<b>Process Change Notice</b>										<div>Hirose Electric Co., Ltd. Koriyama plant Quality control section ヒロセ電機株式会社 郡山工場 品質管理課</div> <table><tr><td>Approval</td><td>Review</td><td>Creation</td></tr><tr><td>塚本 Tsukamoto</td><td>稲垣 Inagaki</td><td>野内 Nouchi</td></tr></table>								Approval	Review	Creation	塚本 Tsukamoto	稲垣 Inagaki	野内 Nouchi
Approval	Review	Creation																					
塚本 Tsukamoto	稲垣 Inagaki	野内 Nouchi																					
<p>We truly appreciate your significant support always.</p> <p>We are currently planning on the below process change for the products planned to be delivered to your company.</p> <p>Forwarding shares the notification of the process change. Your approval on the change will be appreciated.</p> <p>貴社益々ご清栄のこととお喜び申し上げます。</p> <p>日頃は弊社製品のお引き立てを賜り、厚く御礼申し上げます。</p> <p>早速ですが、貴社への納入製品について、下記の通り工程変更を計画しております。</p> <p>つきましては、本書にて工程変更のご案内をさせていただきますので、変更に際してのご承認を賜りたくお願い申し上げます。</p>																							
Customer's product number / 貴社品番						Product number by Hirose / 弊社品番						Product name by Hirose / 弊社品名											
						609-0019-5						DM3C-SF											
						609-0032-3						DM3CS-SF											
Content of change / 変更内容	Type 区分	① Addition of contact plating com

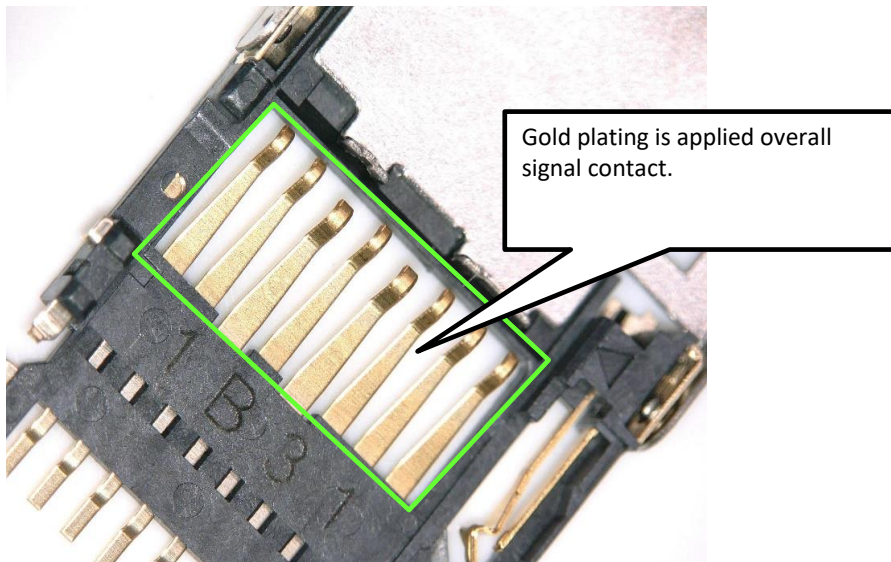
## Current specification

## New specification
